Reviewers' comments:

The authors present work on developing a biodegradable wireless device for drug delivery intended for the treatment of brain tumors. The authors show through extensive in vitro and in vivo models that their device with thermic actuation can deliver doxorubicin at sufficient quantities to effect tumor growth in a flank murine model and canine brain tumor model. They also present behavioral and safety data. Additionally the MRI compatibility of the BEP is a positive aspect of the device. We approve this manuscript's acceptance for publication once some concerns, outlined below, are addressed.

Our modification: (Fig. 4a: in revised main text)

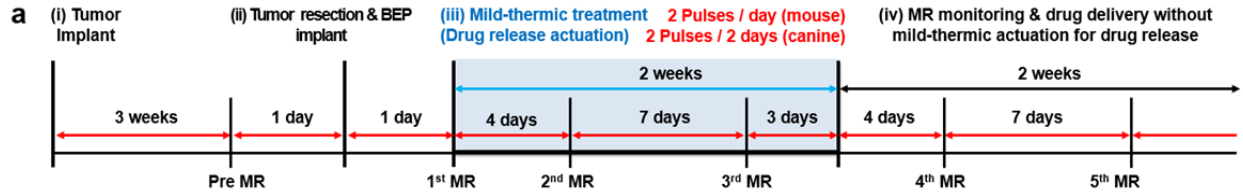
Comment #10: Figure 4 should state which animal model is being referred to in all images (4a-4j). It is confusing. Also does the time table refer to just the mouse model or both models? Please clarify.

Our response: We thank the reviewer for the comment. Figure 4b-e are for the mouse model, and Fig.

4f-j are for the canine model. We modified Fig. 4a to address this information in the timetable clearly. We also clarified this point in the figure caption accordingly.

(Fig. 4a: in revised main text)

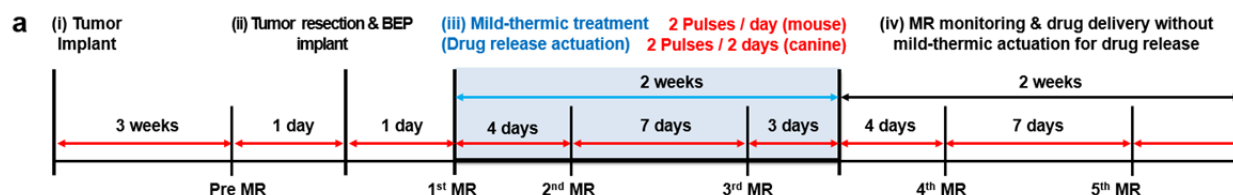
Comment #14: *For the canine study how many pulses total were given? How many dogs total? Was the “control polymer” a polymer containing carmustine?*

Our response: 2 pulses per every 2 days were applied for the canine study, and 2 dogs were used for each group. ‘Control polymer’ is composed of 194.4 mg poly[bis(p-carboxyphenoxy)propane] and 7.7 mg carmustine. We clarified these points in the revised manuscript.

(Fig. 2h and i: in revised main text)

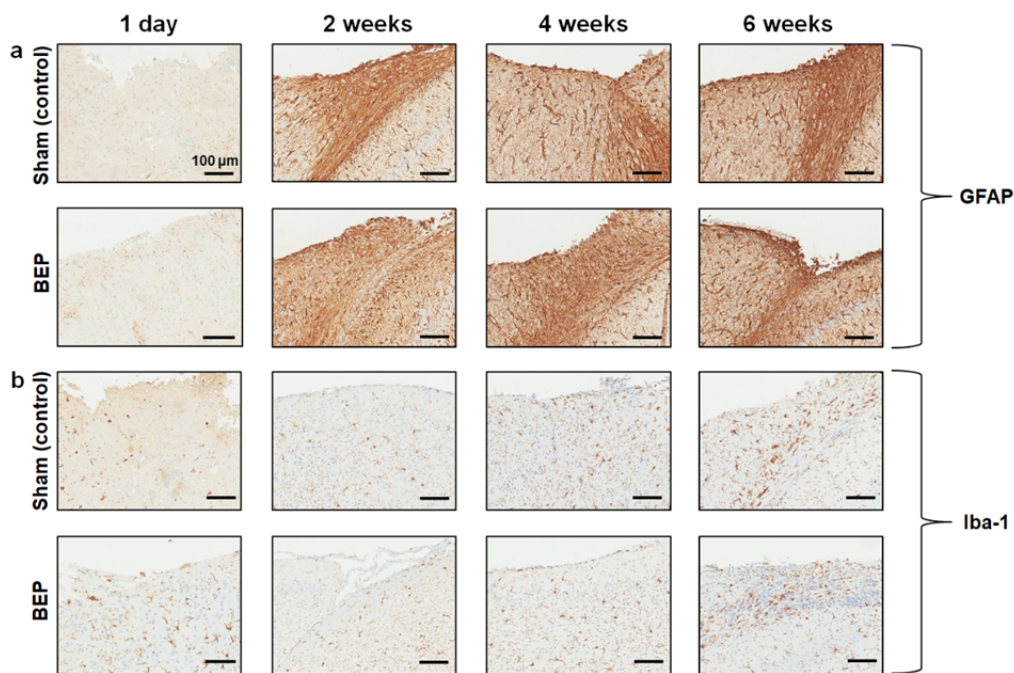
Comment #2: Results in Figure 2 h and I are difficult to see. Quantification of the immunohistochemistry would help.

Our response: We are grateful for the reviewer's comment. We quantified the GFAP- and Iba-1-stained cells in the sham and BEP implantation group near the surgery site to study the foreign body response. 7-8 BALB/c nude mice that we used to study the BEP were used for the investigation over 4 time points (1 day, 2 weeks, 4 weeks, and 6 weeks from the implant surgery). The sham group exhibited the accumulation of astrocytes and microglia from 2 weeks, but the degree of accumulation was maintained up to 6 weeks, which suggests no significant increase of the immune response after 2 weeks (Fig. 2h and i). Also, the accumulation of astrocytes and microglia in the BEP implantation group is similar to the sham group. According to these results, the BEP did not induce significant foreign body responses up to 6 weeks. We modified the text accordingly.

Quantification of the immunohistochemistry using BALB/c nude mice at different time points for the sham (red) and BEP implantation (blue) group (n = 7-8 for each group and time): (h) for GFAP and (i) for Iba-1. (NS = not significant)

(Supplementary Fig. 13 in revised Supplementary Information)

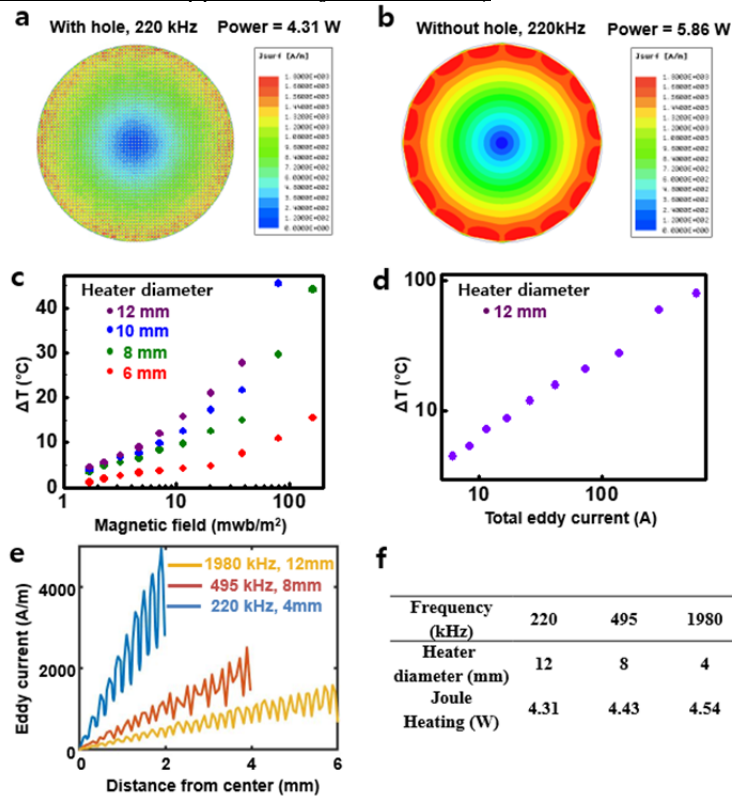
Comment #2: They should also elaborate on the principles underlying the design of the eddy heater – what were the key optimization criteria? Would a field with a higher amplitude or frequency afford further miniaturization of the heater? The calibration curve for the temperature as a result of eddy current should be provided (T vs. I or T vs. H).

Our response: Theoretically, the amount of heat generation (W) is proportional to the integrated value of eddy currents in the heater (Equation 1 and 2), which is a function of the coil-to-heater distance (h), current of the transmission coil (I), number of the coil turn (N), coil radius (a), RF frequency (ω), heater thickness (t), and heater diameter (D) (Equation 3), assuming the device as a round-shaped magnesium plate. Since N , a , and ω are fixed by the instrument (magnetic field generator), the key parameters for the design are thickness (t) and diameter (D) of the wireless heater. The other parameters, coil-to-heater distance (h) and current in transmission coil (I), can also be optimized during the experiment. However, their variation is somehow limited; the coil-to-heater distance should be larger than 2-3 cm for the large animal application, and the coil current is limited by the instrument specification. Therefore, the most important parameters are heater thickness (t) and diameter (D), which are expressed as bold in equation 3.

We added a plot of the temperature increase as a function of the magnetic field (Supplementary Fig. 13c) and total eddy current (Supplementary Fig. 13d) using above equations. We also added detailed explanations in the main text and Supplementary Information accordingly.

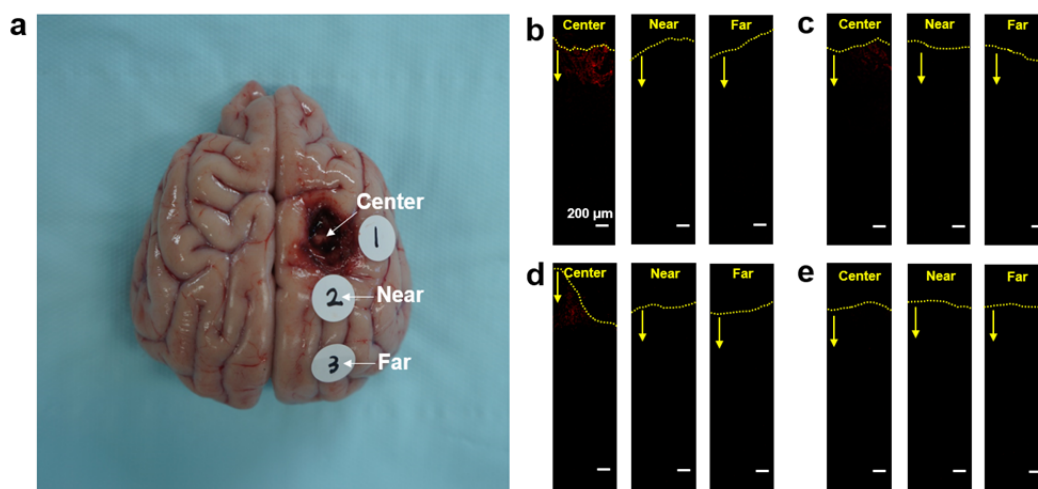
Comment #3: *The authors emphasize the degradable nature of their patch. Simultaneously they design the patch to be unidirectionally functional, releasing drugs toward the brain while avoiding excessive leakage into the epidural or subdural space. I am very perplexed by this concept. First, the tumor cavity is unlikely to have a uniform shape enabling precise placement of the patch in a manner that only permits release into the brain. Second, as the device degrades, the drug is expected to leak essentially everywhere in the cavity. The authors should show profiles of the drug leakage overlaid with device degradation – immunohistochemistry with the device still in place over an entire operation window would be most enlightening.*

Our response: We thank the reviewer for valuable comments. As the reviewer pointed out, the perfect unidirectional diffusion cannot be achieved due to incomplete coverage of the tumour cavity by the BEP particularly during its biodegradation. What we intended was to reduce/minimize the drug release to the CSF. Therefore, we modified the text to clarify this issue. We additionally carried out the histology analysis to confirm the suppressed drug leakage. We observed the fluorescence of the drug at 3 different locations (Supplementary Fig. 6a) to visualize the drug leakage to the nearby tissue. Compared to the site 1 (implanted position), the site 2 (nearby position) and site 3 (distant position) exhibited much lower fluorescence, which means that the concentration of the drug is much lower. We added the data and the related texts accordingly.

(Fig. 2h and i: in revised main text)

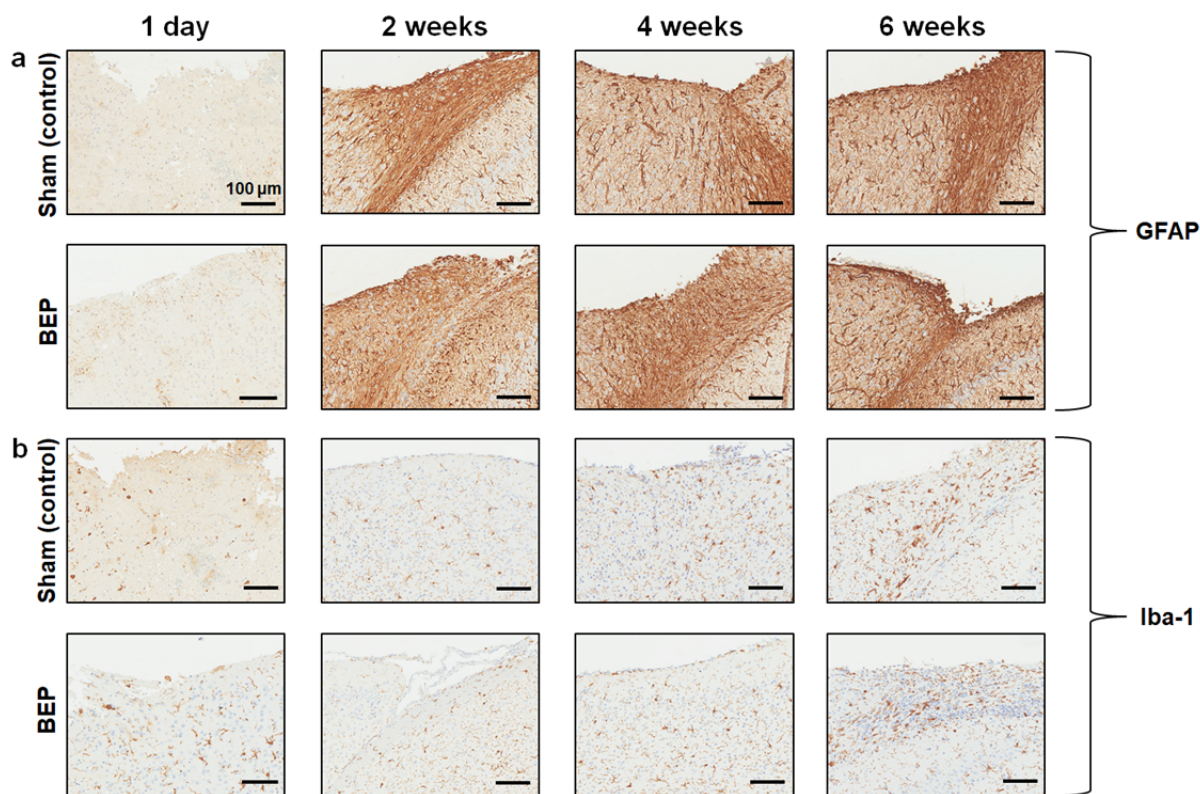
Comment #5: Immunohistochemistry analyses of the foreign body response are somewhat qualitative. The data should be shown for multiple animals (typically $n=5-8$) for several time points within the lifespan of the device. These data should be collected in the brain of the same mouse models used for GBM evaluation experiments.

Our response: We are grateful for the reviewer's comment. We quantified the GFAP- and Iba-1-stained cells in the sham and BEP implantation group near the surgery site to study the foreign body response. 7-8 BALB/c nude mice that we used to study the BEP were used for the investigation over 4 time points (1 day, 2 weeks, 4 weeks, and 6 weeks from the implant surgery). The sham group exhibited the accumulation of astrocytes and microglia from 2 weeks, but the degree of accumulation was maintained up to 6 weeks, which suggests no significant increase of the immune response after 2 weeks (Fig. 2h and i). Also, the accumulation of astrocytes and microglia in the BEP implantation group is similar to the sham group. According to these results, the BEP did not induce significant foreign body responses up to 6 weeks. We modified the text accordingly.

Quantification of the immunohistochemistry using BALB/c nude mice at different time points for the sham (red) and BEP implantation (blue) group ($n = 7-8$ for each group and time): (h) for GFAP and (i) for Iba-1. (NS = not significant)

(Supplementary Fig. 9c: in revised Supplementary Information)

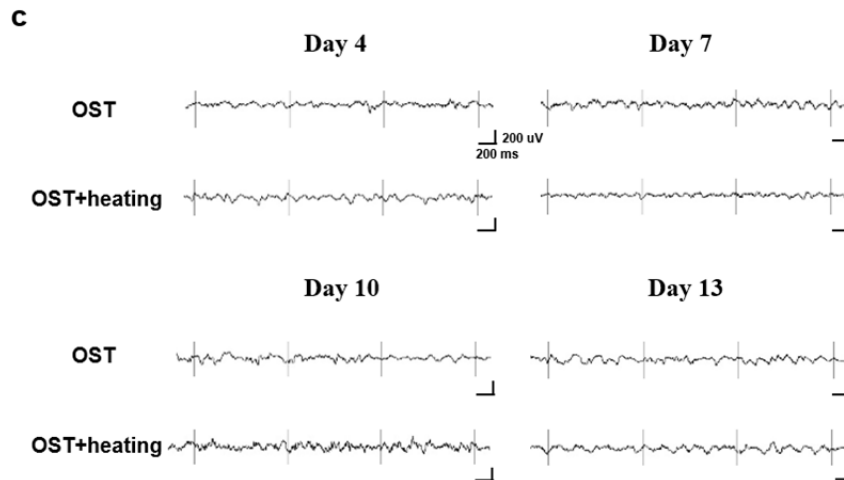
Comment #6-1: *The authors discuss using EEGs as a means to confirm the “normal” state of the brain tissue following implantation of their patches. This entire part of the manuscript is rather confusing. First, looking at the electrode positioning within the brain, it appears that the authors used penetrating electrodes placed within the brain tissue following craniotomy. A typical EEG is performed using electrodes placed on the surface of the skull.*

Comment #6-2: *Second, it is unclear how the data was recorded and filtered. Supplementary Figure 9c does not appear to have any scale bars on either axis. It not even clear what's on the axes.*

Our response: We appreciate the reviewer’s comment. In case of the EEG measurement for the mouse model, EEG can be measured by using the penetrating electrode [1] or the electrode attached on dura [2]. The former method is better in detection of partial seizures although the latter can be used for detection of a big cramp such as epilepsy. The EEG study in this work is to see the influence of the BEP on the electrophysiological activity, and therefore we chose to use the penetrating electrode to detect any potential partial seizures [1]. But to prevent confusion from the conventional surface EEG measurement, we changed the terminology from EEG to iEEG (intracranial EEG) in our revised manuscript.

“(c) **Intracranial electroencephalograms (iEEGs)** of the sham operating group and the BEP implantation group at different time points.”
